# Road & Bridge Design Publications

## Monthly Update – January 2023

Revisions for the month of **January** are listed and displayed below and will be included in projects submitted for the **May** letting.

DATE:	CS:	EXPANSION JOINT DETAILS	DRAWING SHEET
DESIGN UNIT:	JN:		
TSC:			
FILE:	EJ3AF (01-23-2023)		SECT

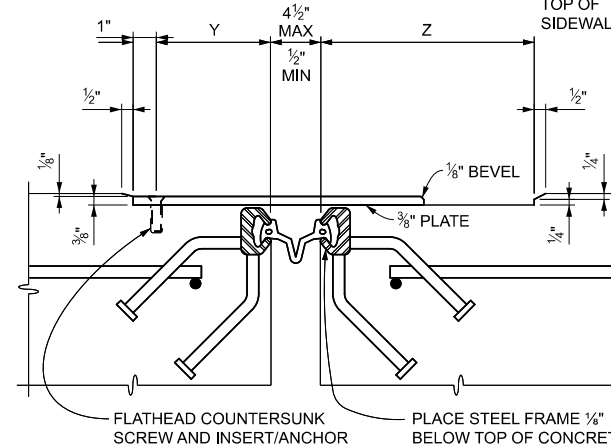
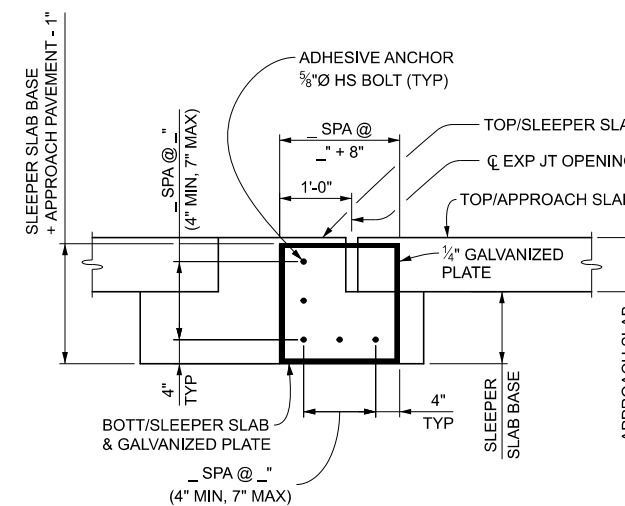
EJ3AF & EJ4S: Added criteria for cover plates greater than 11 feet. Provide and detail two plates with joint at centerline of sidewalk or path. This will ease fabrication and installation of long plates.

COVER PLATES WITH A LENGTH GREATER THAN 11' MAY BE FABRICATED FROM TWO EQUAL LENGTH PIECES WITH A JOINT LOCATED AT THE CENTERLINE OF THE SIDEWALK OR PATH. PROVIDE A 1/4" WIDE GAP AT THE JOINT THAT IS PARALLEL TO THE CENTERLINE OF THE SIDEWALK OR PATH.

6.20.01

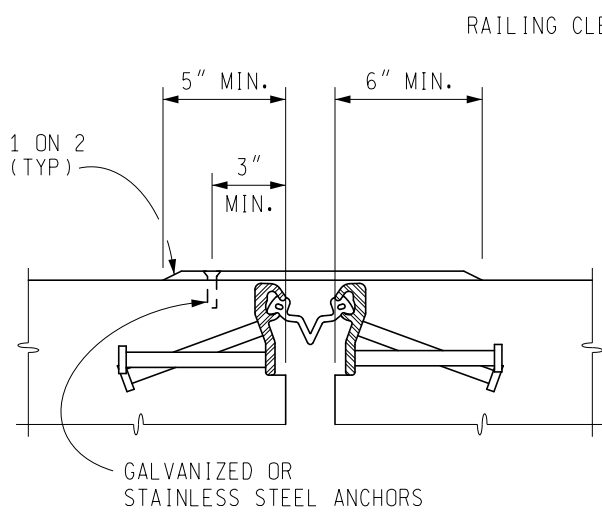
6.20.01: Increased the pavement seat width to 9". Added minimum clearance from masonry plate/elastomeric pad to front face of abutment.

6.28.06

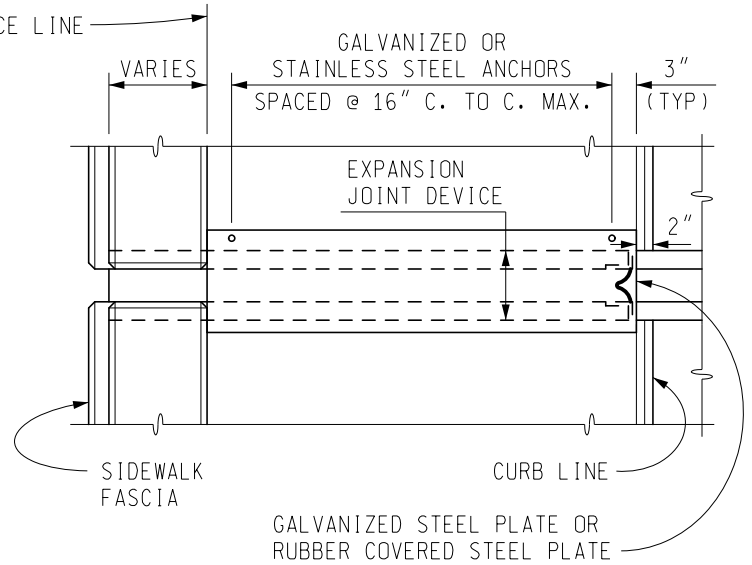
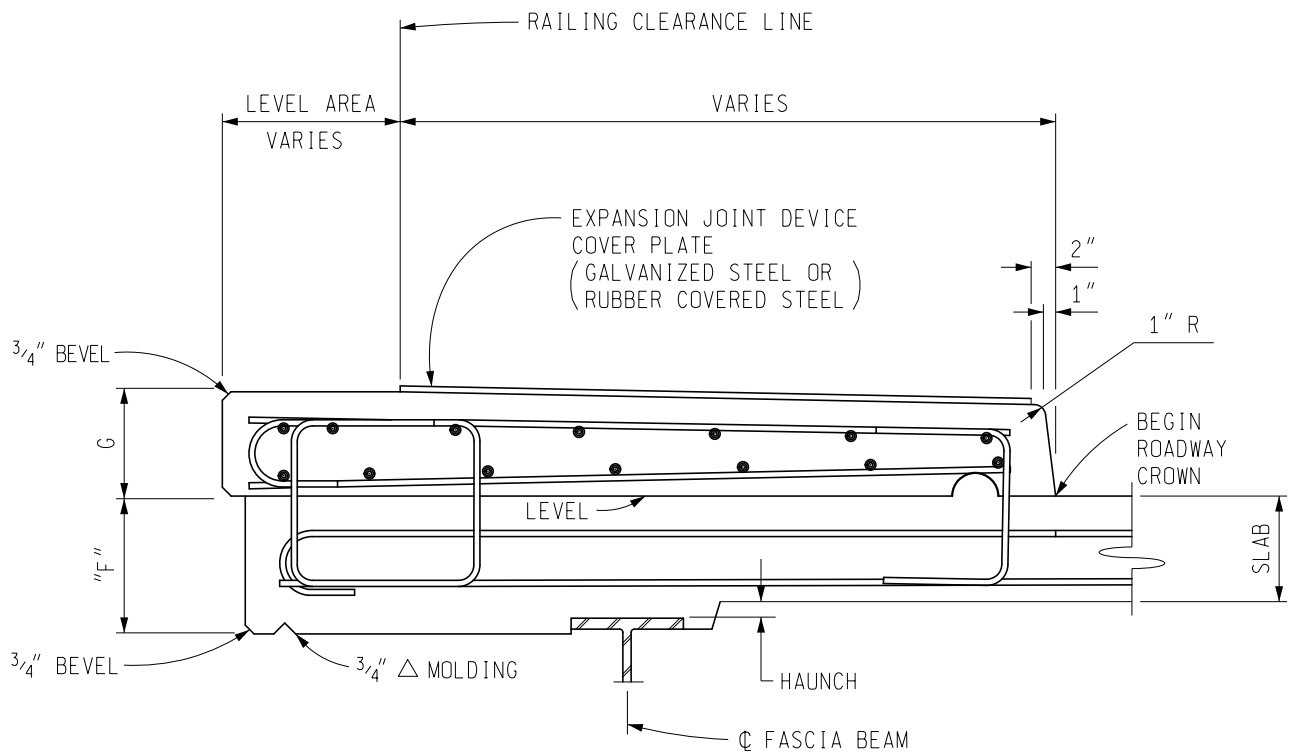
6.28.06: Added criteria for expansion joint device cover plates greater than 11 feet long for retrofit situations.

DETAIL COVER PLATES THAT REQUIRE A LENGTH GREATER THAN 11' TO BE FABRICATED FROM TWO EQUAL LENGTH PIECES WITH A JOINT LOCATED AT THE CENTERLINE OF THE SIDEWALK OR PATH. PROVIDE A 1/4" WIDE GAP AT THE JOINT THAT IS PARALLEL TO THE CENTERLINE OF THE SIDEWALK OR PATH.

BULB TEE  
 BEAM REINFORCEMENT

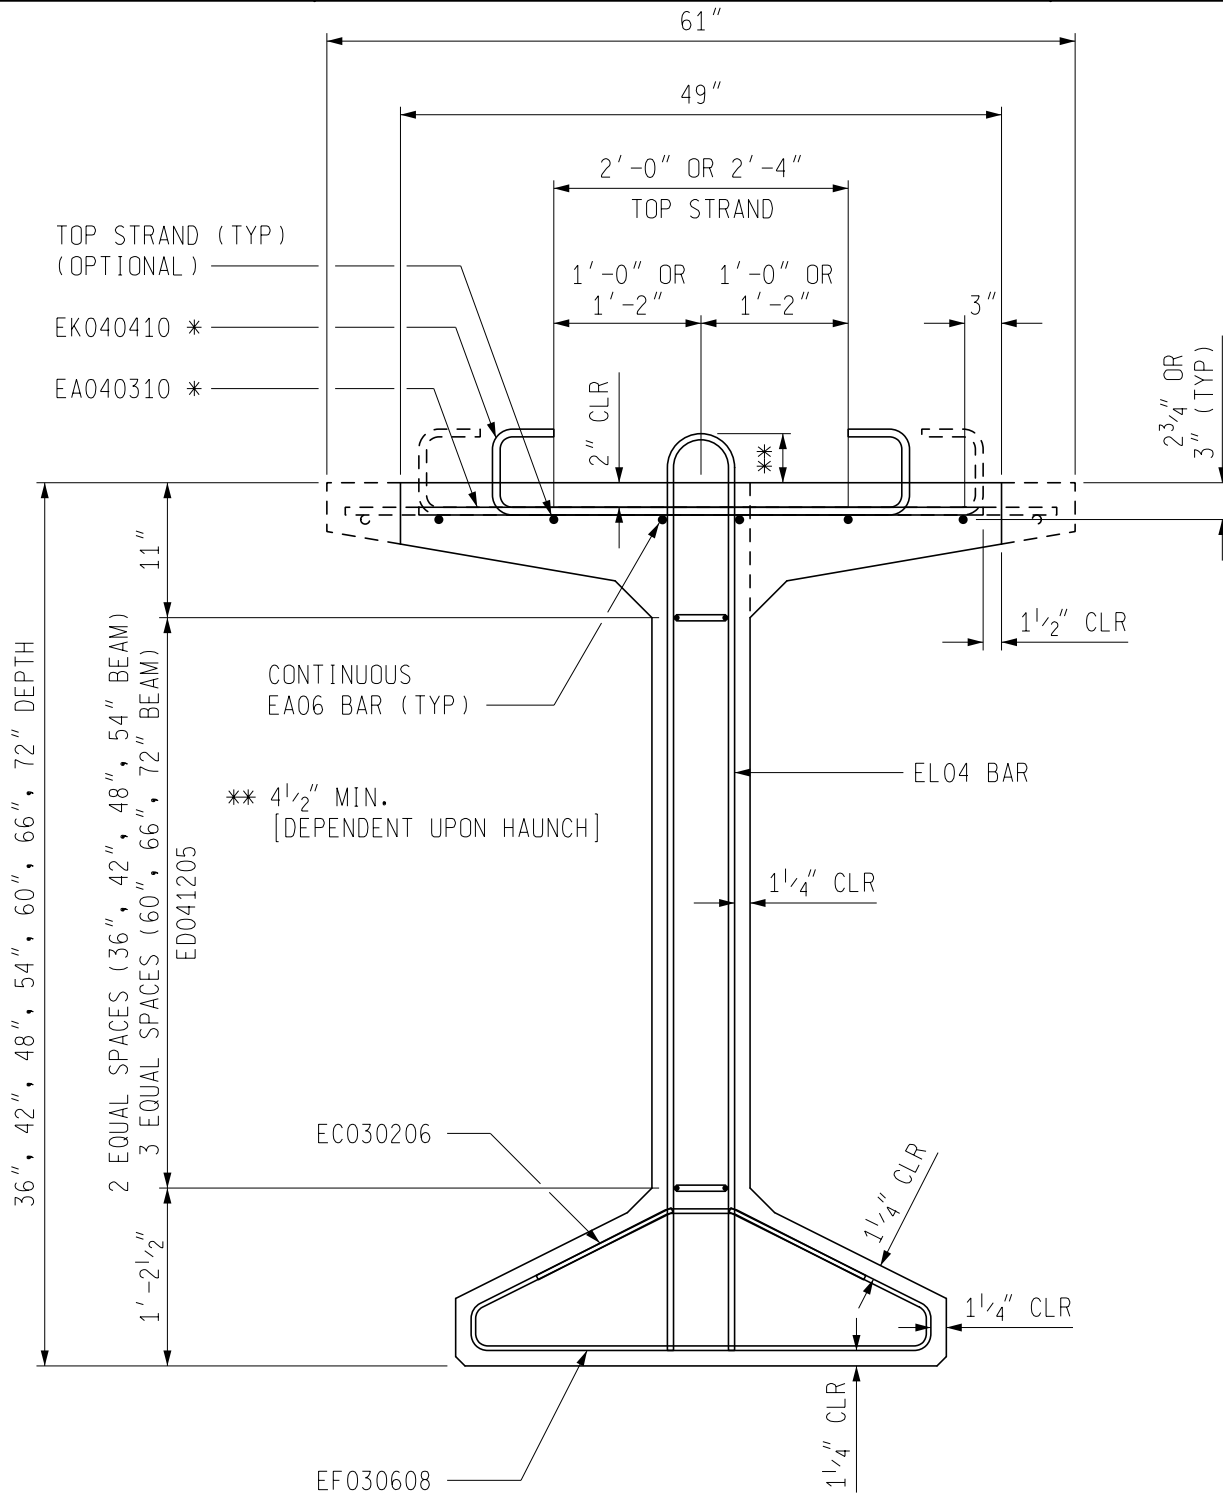
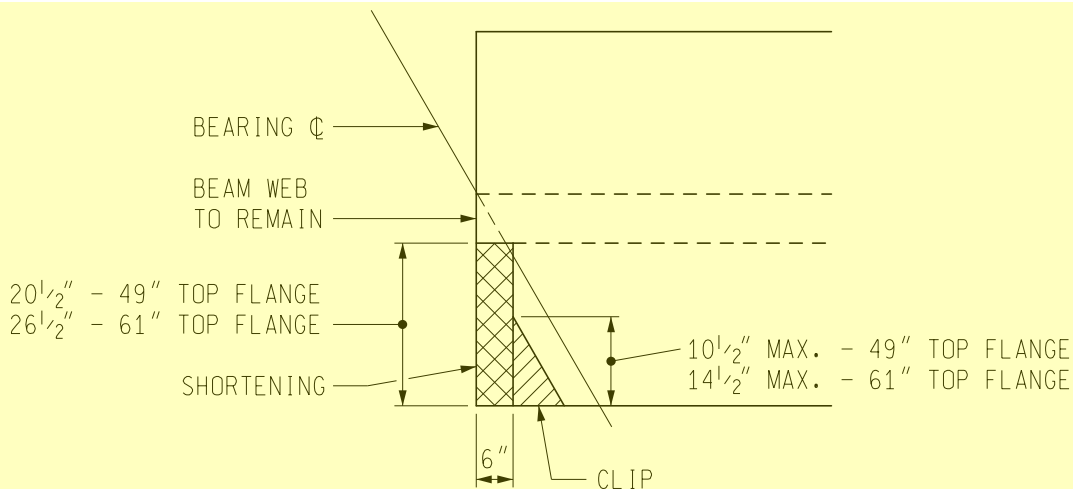
6.60.03A: Added top flange reinforcement criteria when the top flange is shortened/clipped.

\* ALTERNATE EKO4 WITH EA04 BARS IF REQUIRED FOR SHEAR/COMPOSITE ACTION. USE EA040410 AND EKO40510 WITH BLOCKOUT REMOVAL / 61" TOP FLANGE, SEE GUIDE 6.60.03B. DECREASE EA04 BAR LENGTHS AT SHORTENED AND/OR CLIPPED TOP FLANGE AND START ALTERNATING EA04 AND EKO4 PAST SHORTENING/CLIP. SEE GUIDE 6.60.03C FOR BEAM FLANGE SHORTENING/CLIP DETAILS.

6.60.03C

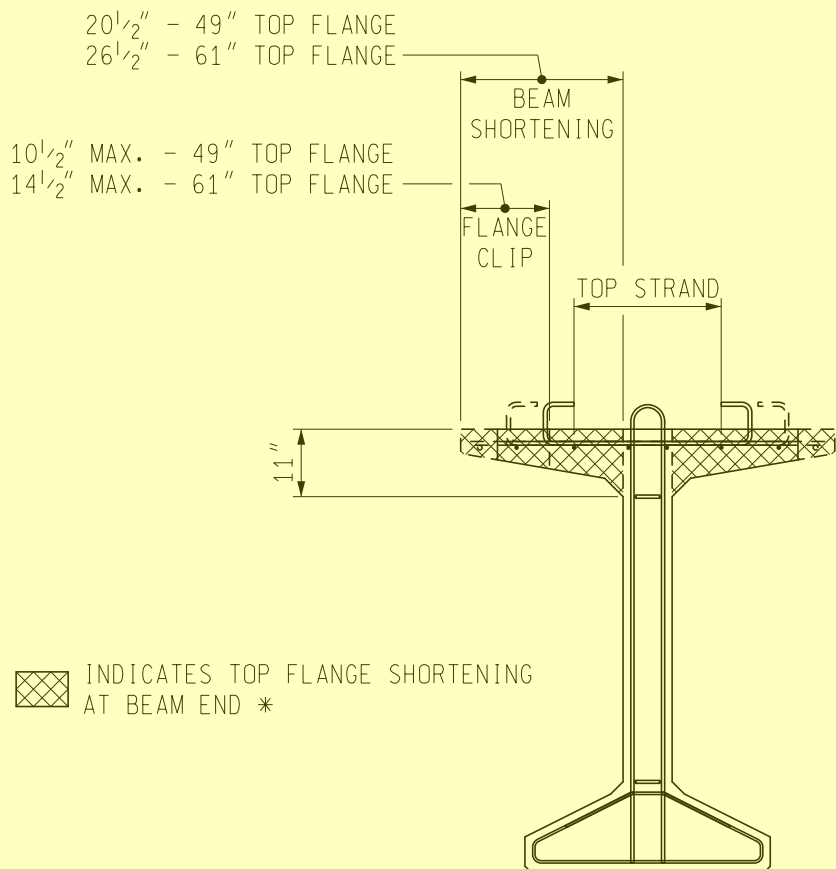
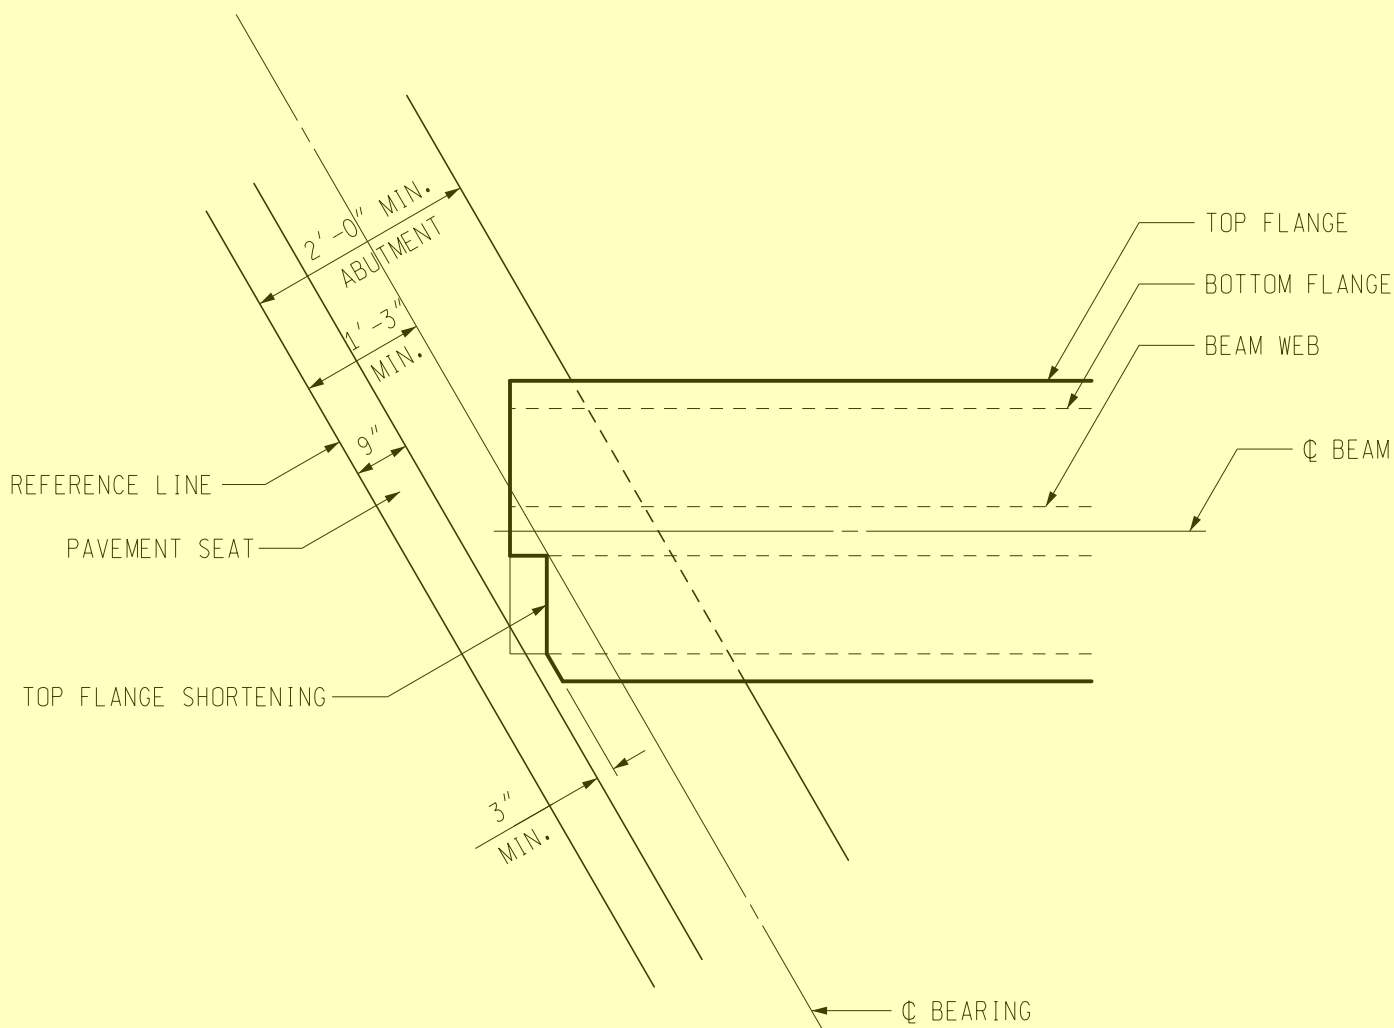
6.60.03C: Entire guide is redone. Beam ends are to be made square regardless of angle of skew (see Bridge Manual Section 7.02.18 C.3.). Beam top flanges can be shortened or clipped to provide additional clearance for pavement seats and to decrease substructure unit widths.

SHORTEN APPROPRIATE FLANGE WITH RESPECT TO CENTERLINE BEARING. CLIP SHORTENED FLANGE AS REQUIRED TO PROVIDE ADDITIONAL CLEARANCE FOR PAVEMENT SEAT.

\* WHEN NEEDED SHORTEN THE BEAM FLANGE FROM THE EDGE OF THE FLANGE TO THE WEB OF THE BEAM. SHORTENING OR NOTCHING THE BEAM WEB IS NOT ALLOWED. SHORTEN AND OR CLIP TO PROVIDE CLEARANCE FROM PAVEMENT SEAT AND TO DECREASE SUBSTRUCTURE UNIT WIDTH.
